REMARKS

This is intended as a full and complete response to the Office Action dated August 31, 2006, having a shortened statutory period for response set to expire on November 30, 2006. In the specification, paragraphs [0018], [0030], [0036] and [0037] have been amended to correct minor editorial problems. In amended Figure 3, Y_2 has been added between lines 350 and 360. Claims 1, 12, 13, 17 and 23 have been amended to more clearly recite various aspects of the invention. Applicants believe no new matter has been introduced by the amendments presented herein. The amendments have been made in a good faith effort to advance prosecution on the merits. Please reconsider the claims pending in the application for reasons discussed below.

FIG. 3

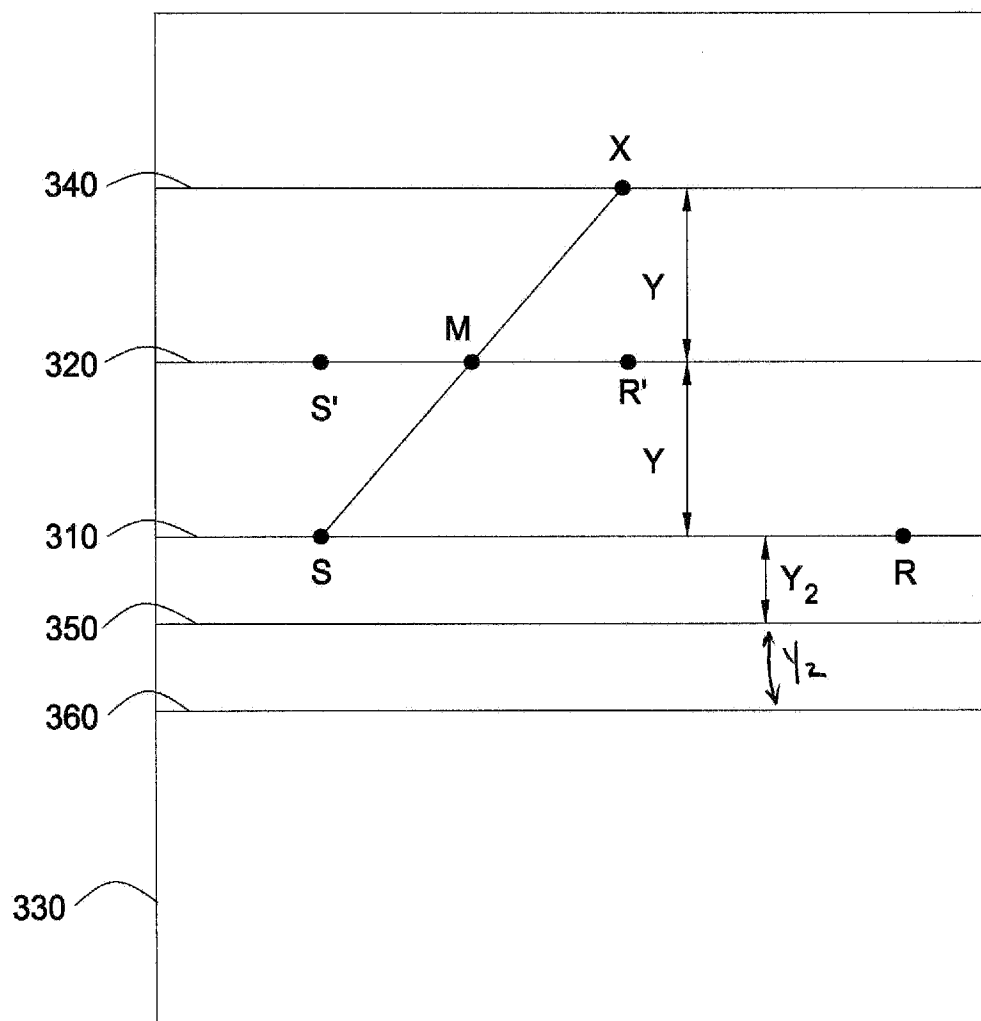
The Examiner objects to Figure 3 for lacking clarity. In particular, the Examiner takes the position that Figure 3 lacks written descriptions for the various depths shown. Further, it is unclear to the Examiner as to which horizontal line represents the water surface and which horizontal lines represent rock interfaces, as opposed to depths at which the source and receivers reside. As explained throughout the specification, the horizontal lines do not represent various depths, water surface or rock interfaces. Figure 3 illustrates a top view of trace (S, R) on target subsurface line (SSL) 310 for which the surface multiples are to be predicted. As such, line 310 represents a target SSL. Line 320 represents an input SSL. See e.g., paragraph [0023]. Line 340 represents a locations-for-X line on which one or more potential downward reflection points are disposed. Line 360 represents yet another locations-for-X line on which one or more potential downward reflection points are disposed. See e.g., paragraphs [0024], [0030] and Figure 2. Line 350

The Examiner objects to Figure 3 because the marker Y_2 should have been drawn between lines 350 and 360. Applicant is grateful to the Examiner for pointing this out. Figure 3 has been amended to add the marker Y_2 between lines 350 and 360. Accordingly, Applicant respectfully requests that the objection be withdrawn.

represents yet another input SSL. See e.g., paragraph [0030]. Accordingly, Applicant respectfully requests that the objection be withdrawn.
